**WOKINGHAM
BOROUGH COUNCIL**

SUBMISSION OF DETAILS TO COMPLY WITH CONDITIONS

**LAND SOUTH OF WOKINGHAM, EAST OF FINCHAMPSTEAD ROAD AND WEST OF WATERLOO ROAD,
WOKINGHAM**

**PLANNING PERMISSION 192928 (CONSTRUCTION OF THE SOUTH WOKINGHAM DISTRIBUTOR ROAD (SWDR)
BETWEEN FINCHAMPSTEAD ROAD AND WATERLOO ROAD, INCLUDING A LINK TO HEATHLANDS ROAD,
TOGETHER WITH ASSOCIATED WORKS)**

Condition 5 levels (213441)

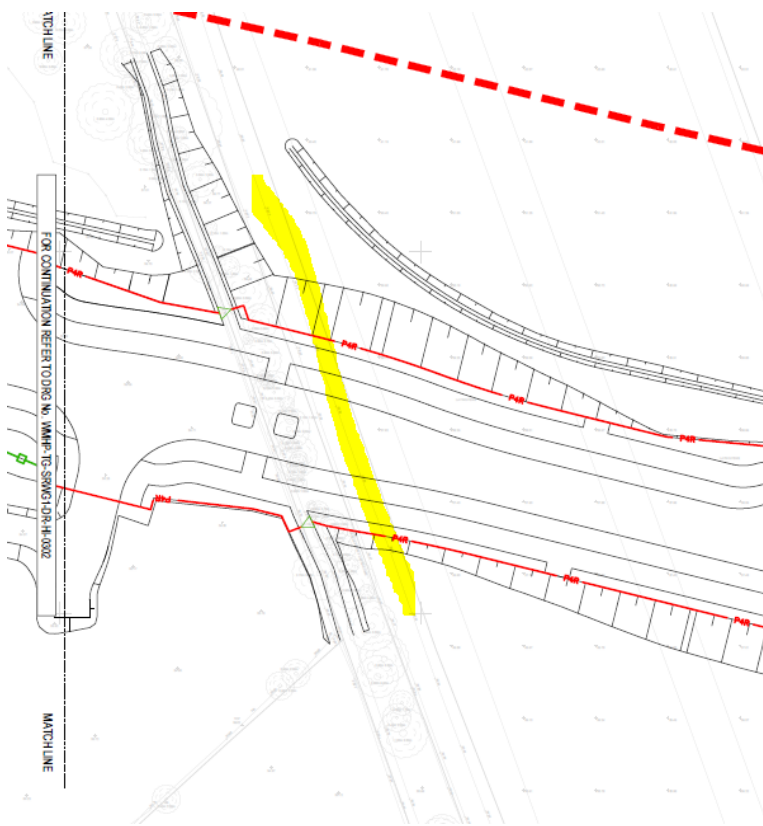
Please provide chainage drawings and longitudinal sections, as provided at the original application stage, showing existing, approved and proposed levels to allow comparison. I am aware that the consortium have raised concerns about the level of the road being increased and need to understand the scope of the issue.

and on WMHP-TG-SRWG1-DR-HI-301:

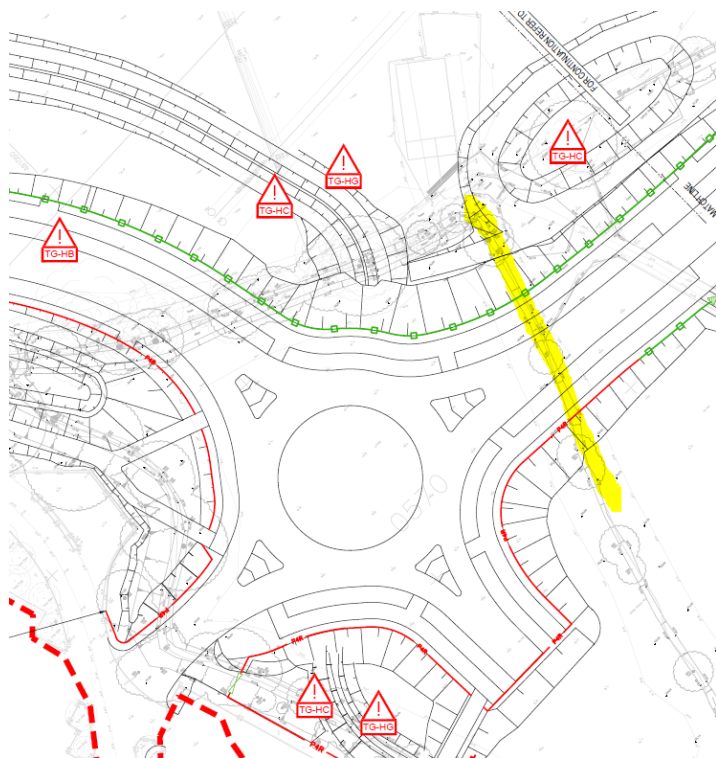
Additional mammal tunnels are required in these two locations, with reference to the fencing plans, on WMHP-TG-SRWG1-DR-HI-0303 (highlighted yellow):

Condition 11 AMS (213554)

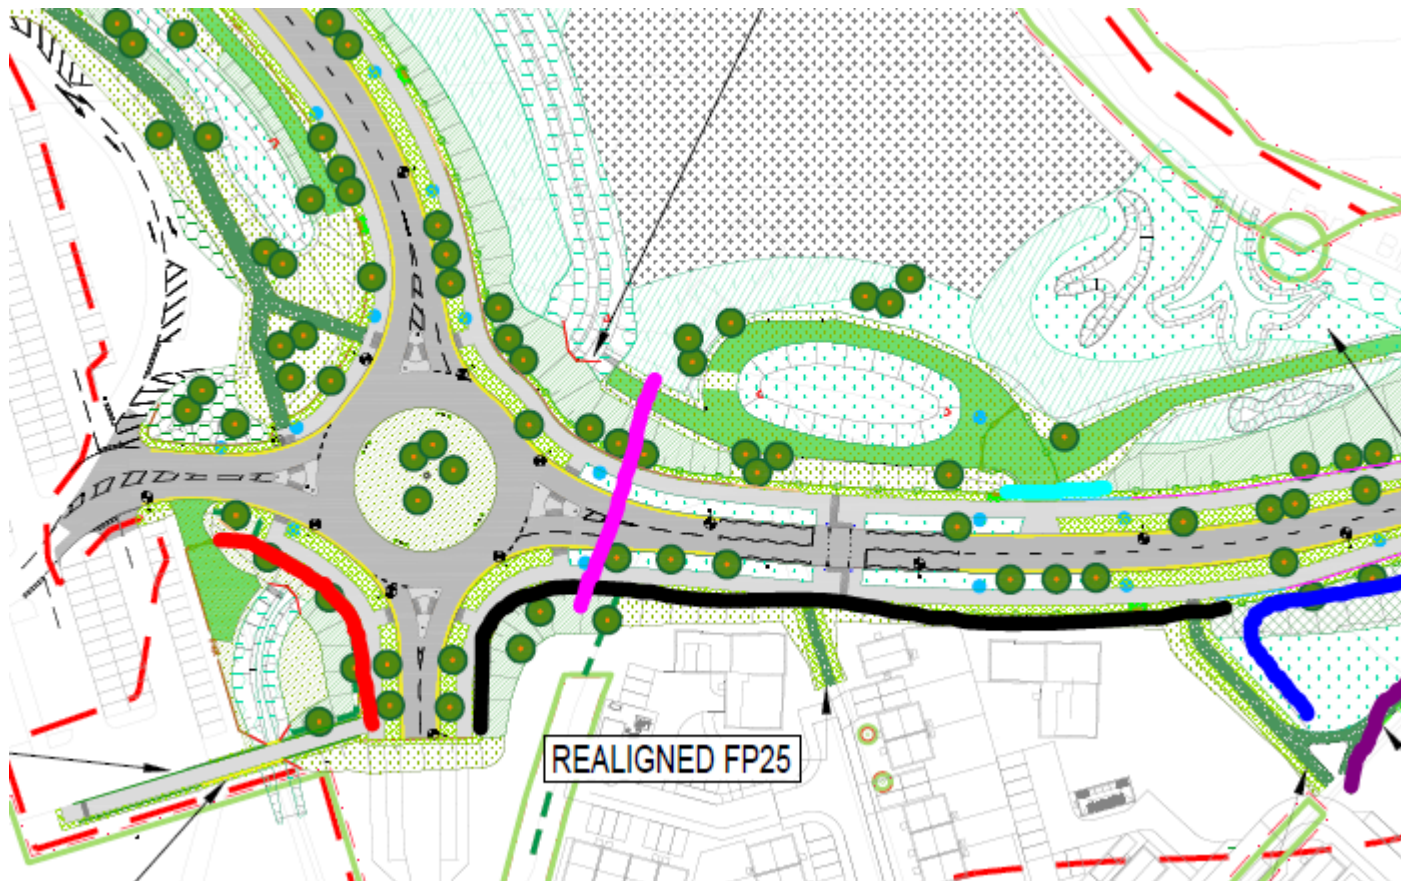
A revised AIA has been submitted but not an AMS which will need to be submitted to comply with this condition.
